## Development Review Division

**SUBJECT:** SP21-063; Douglas 234 F6 L1 - Gas and Convenience Store  
Review Comments 01

# CONVENIENCE STORE SITE PLAN

LOT 1 OF DOUGLAS 234 FILING NO. 6

**P0.0**

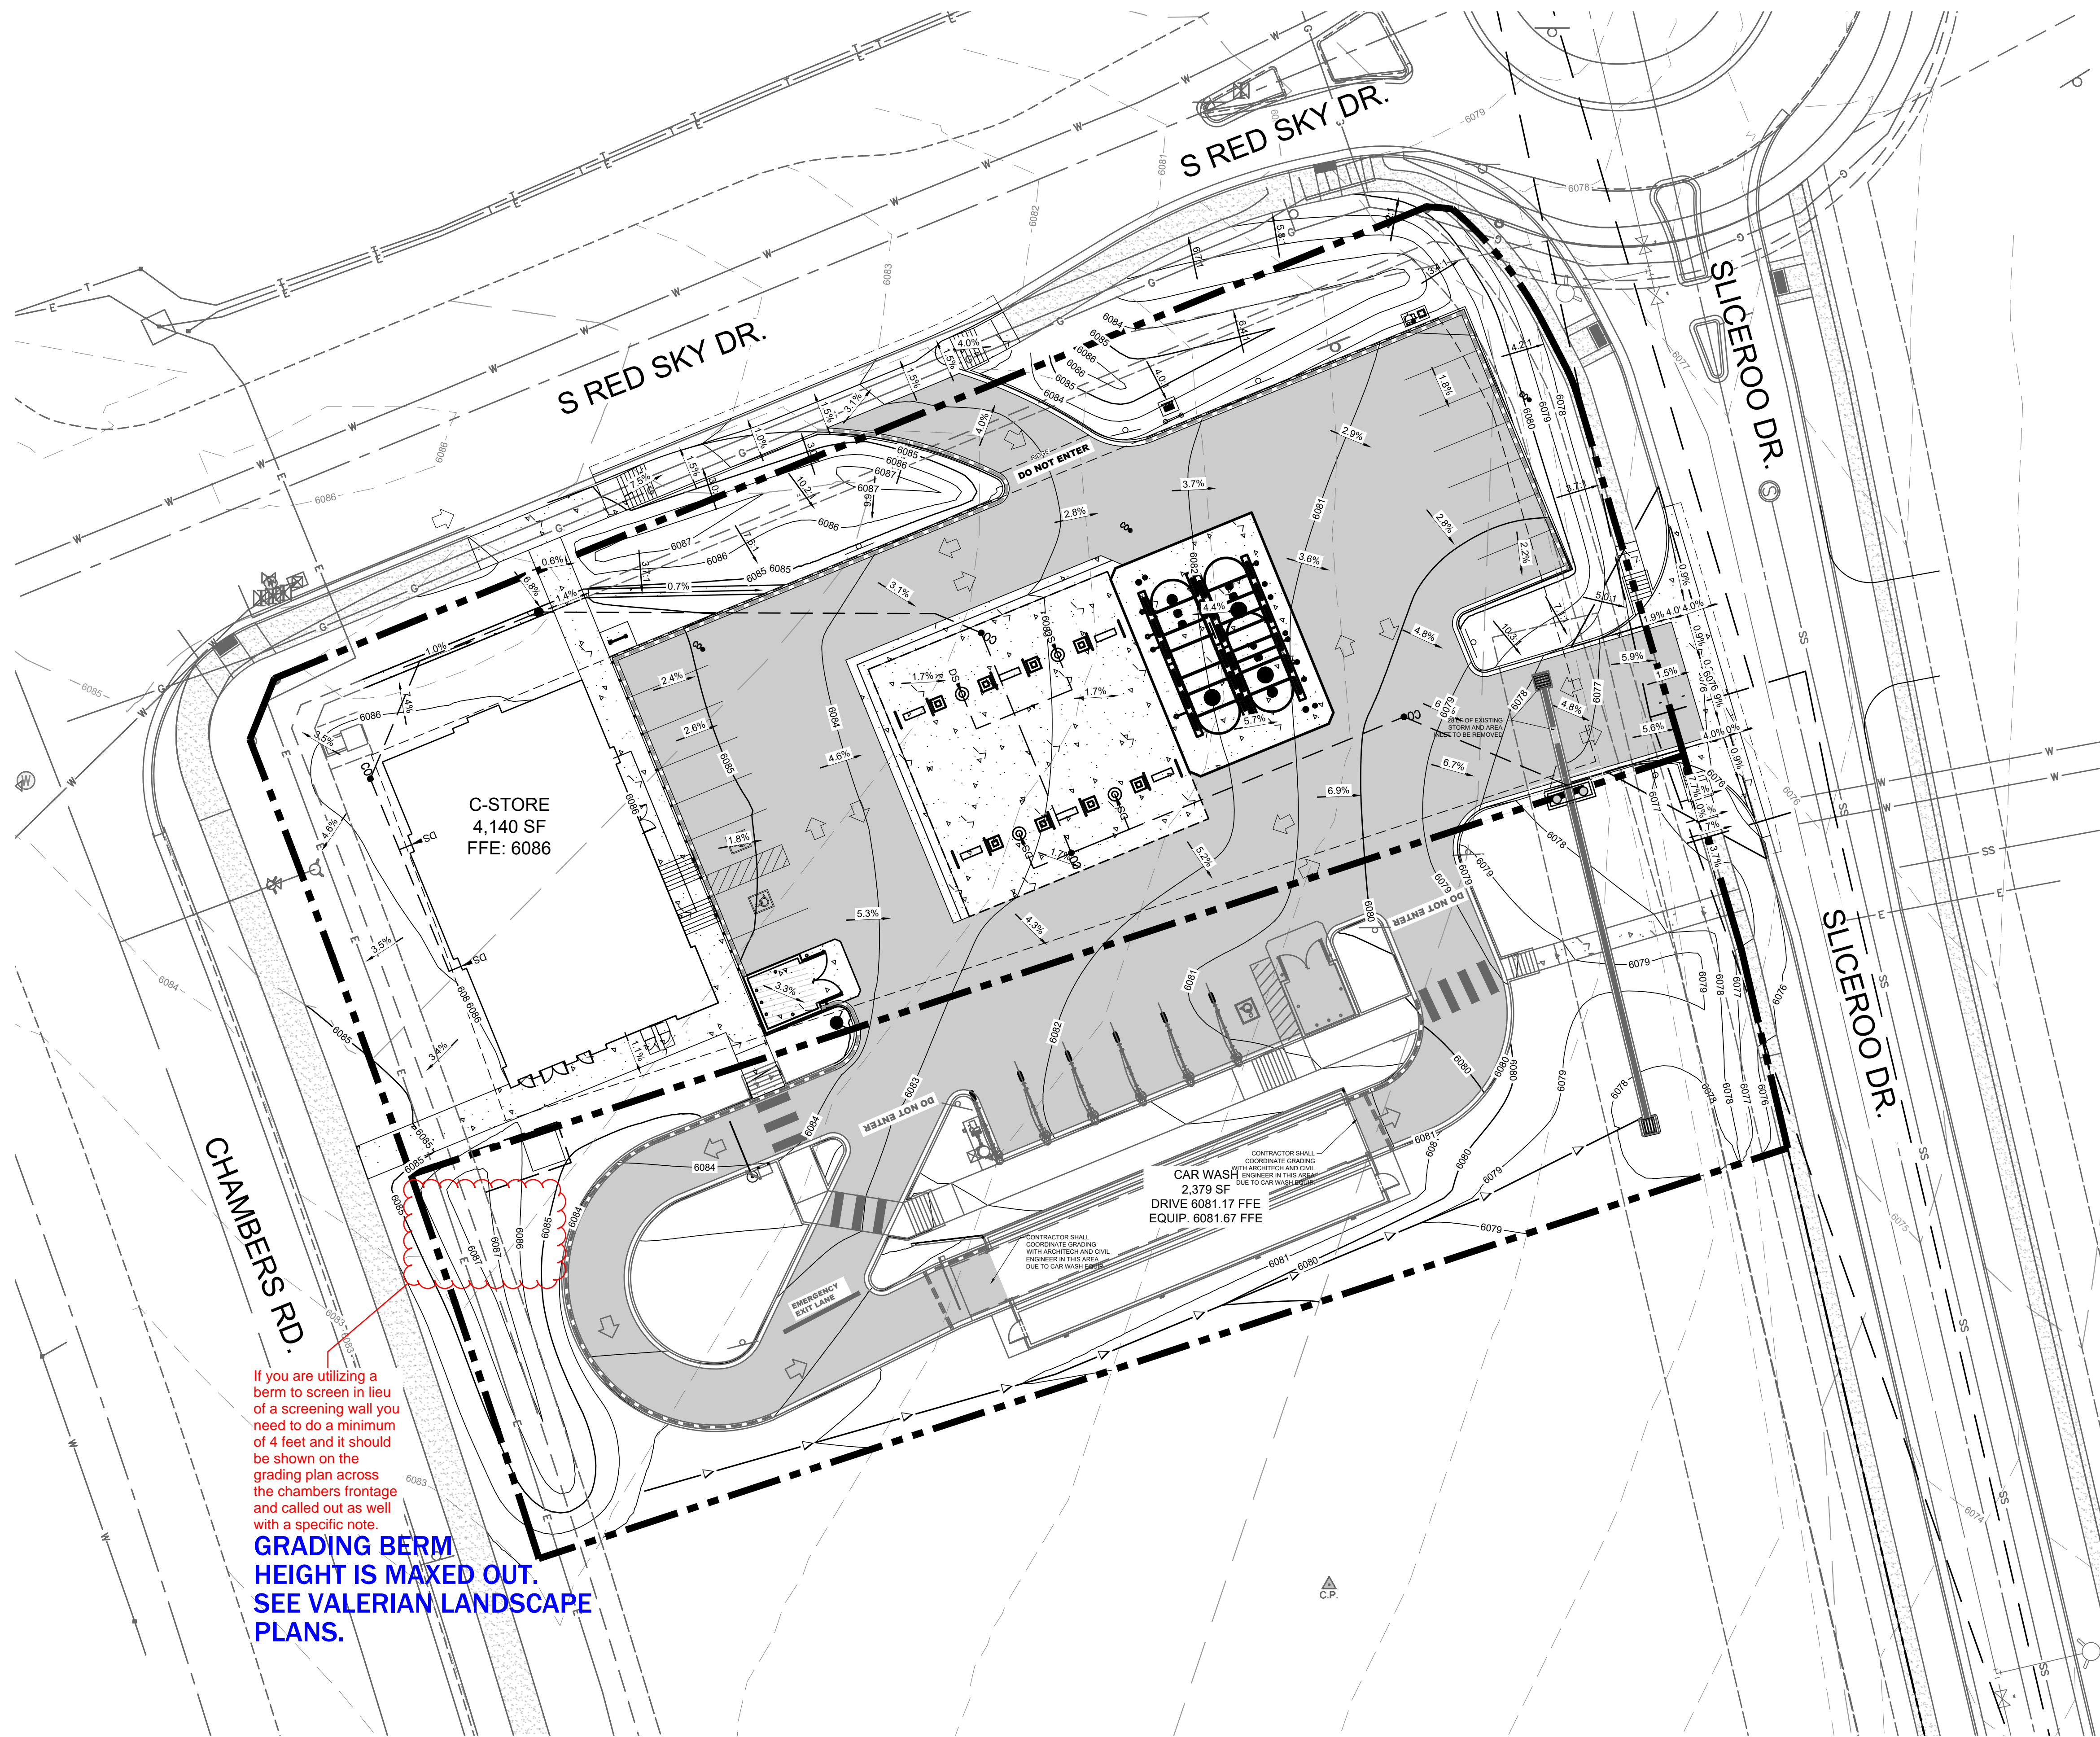
The Legal Description needs to be the main title-switch 1st and 2nd lines

what is labeled side here is actually front, revise COMPLETE

what is labeled rear here is actually side-please revise COMPLETE

The project has three front yards, N,E, and W.

Based on the code and PD, the N, E, and W all have required 25' setback.

Internal Side (south property line requires 10'

Revise to show accurate required vs. actual COMPLETE

DATE		REVISION							
BY		No.							
<b>SITE PLAN LOT 1</b> <b>CONVENIENCE STORE</b> CHAMBERS AND HESS, PARKER, CO <b>GRADING PLAN</b>									
PROJECT NO: TSD003.01									
DESIGNED BY: LCG									
DRAWN BY: JLG									
DATE: 03/19/21									
<b>P2.0</b>

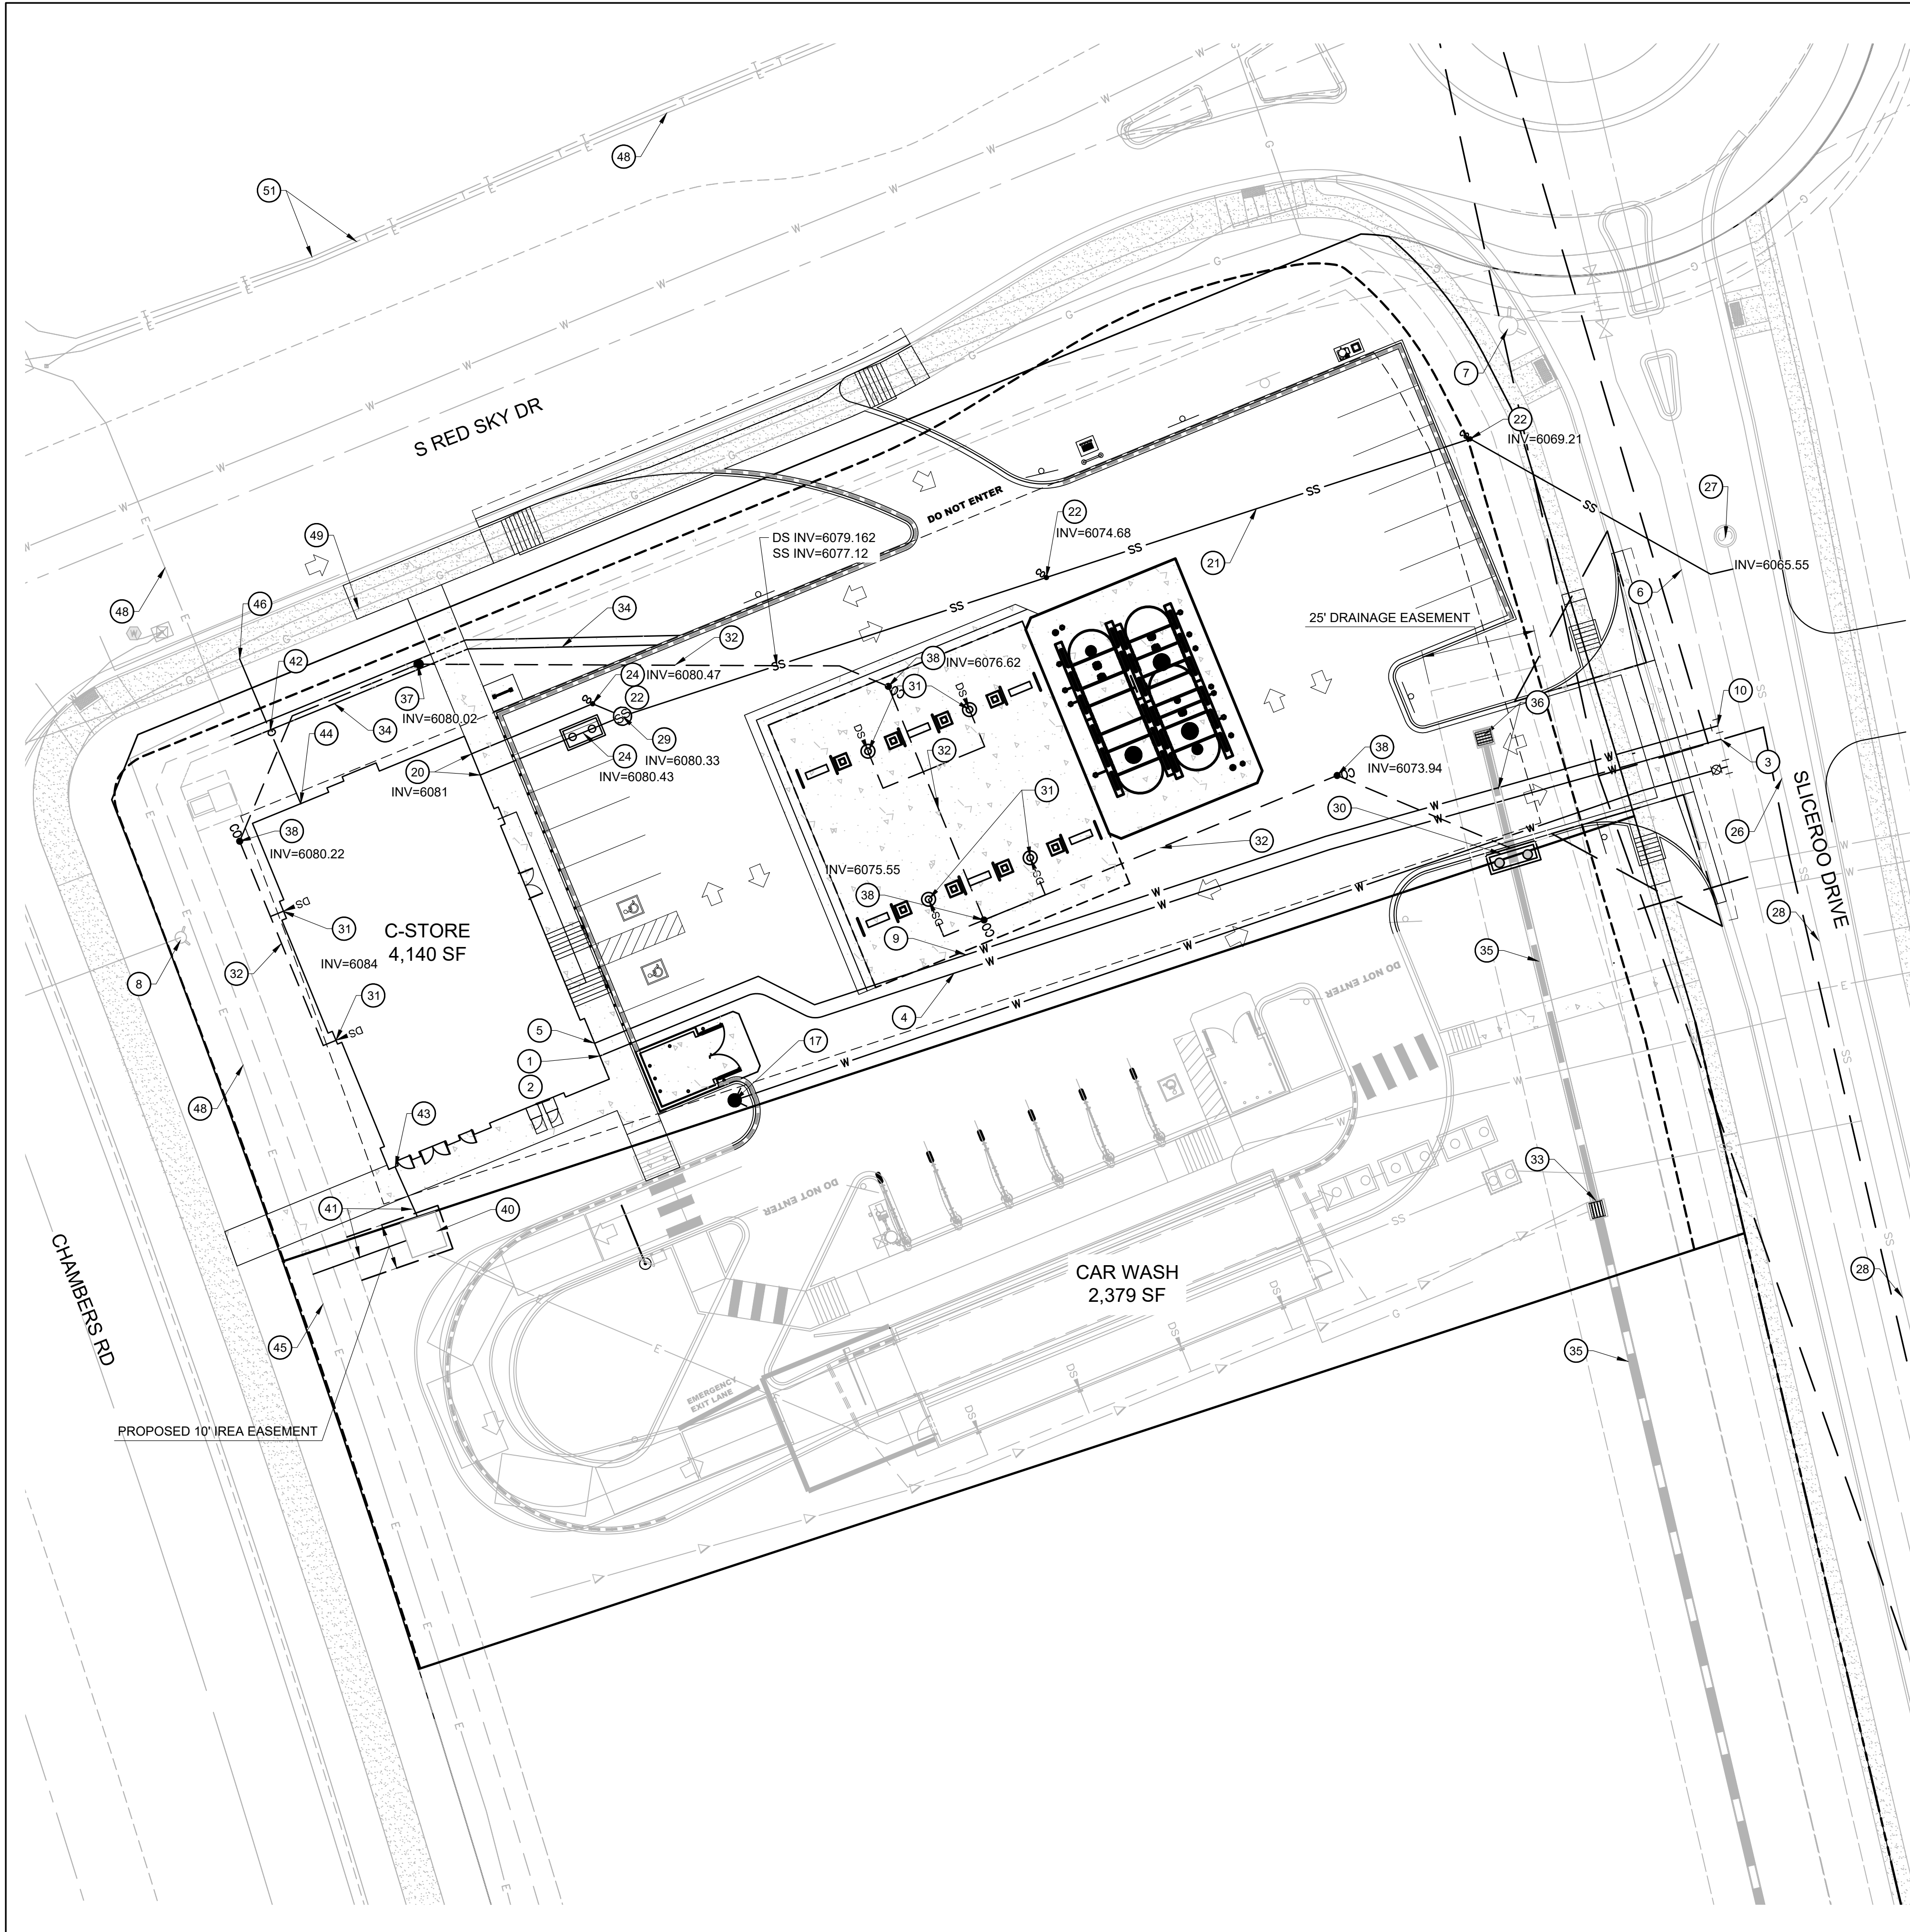
If you are utilizing a berm to screen in lieu of a screening wall you need to do a minimum of 4 feet and it should be shown on the grading plan across the chambers frontage and called out as well with a specific note.

**GRADING BERM HEIGHT IS MAXED OUT. SEE VALERIAN LANDSCAPE PLANS.**
